SFOBB East-Span  
Seismic Retrofit  
Project (SAS)

Report

Week of 2013-1-07

Subject RE: OTD 1 Bike Path Handrailing fix - DJV Suggestions 2

Date: 2013-01-08  
File Name: 0815R3RD-SK-01B

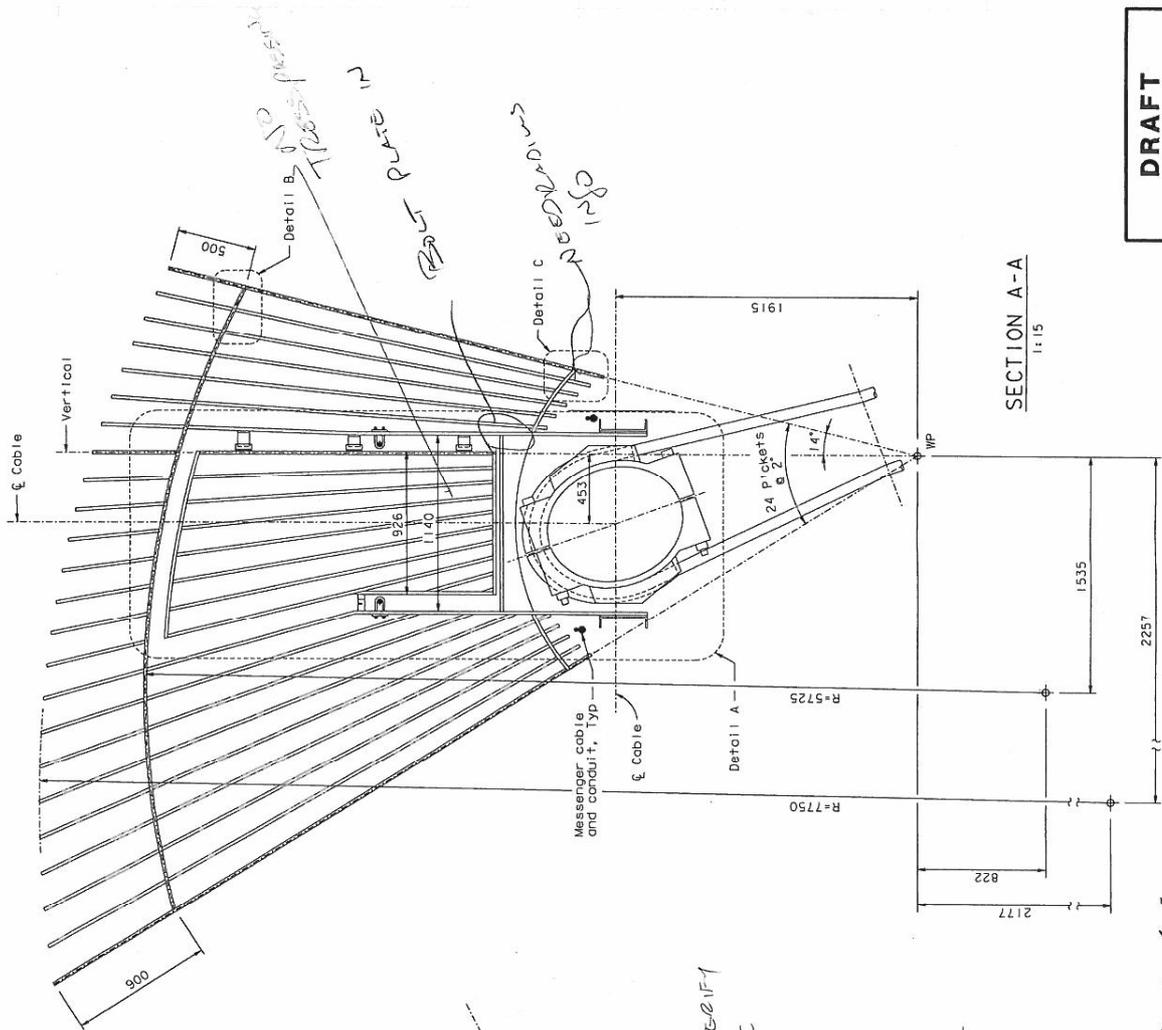
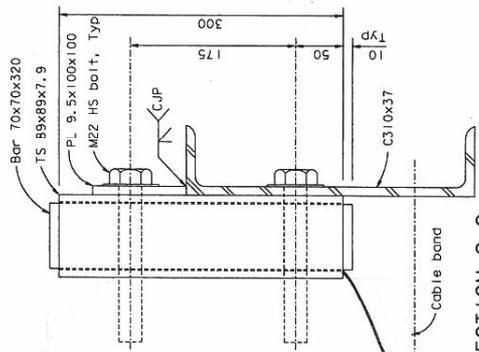
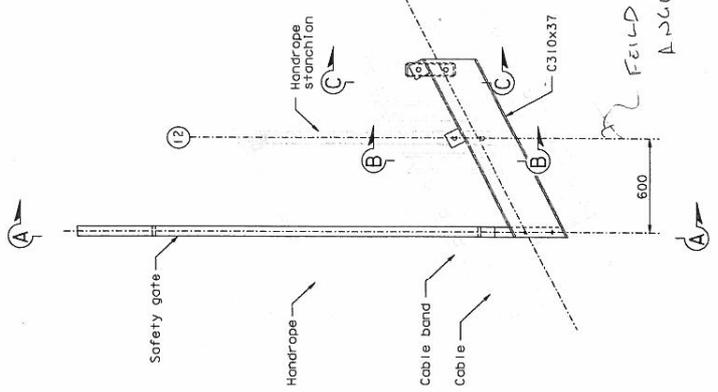
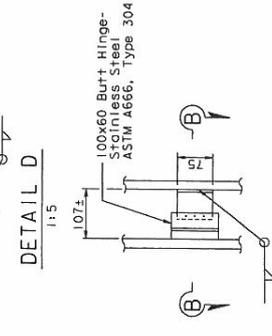
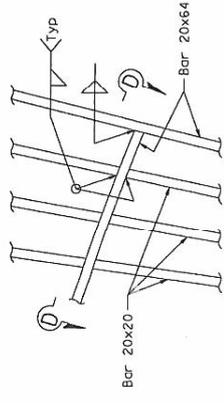
Prepared for and lead meeting to finalize cable security gate revised details. The group was satisfied with the appearance and overall details of the gate. Certain mounting details need revision and TYLin still needs to finalize some of the bolting details.
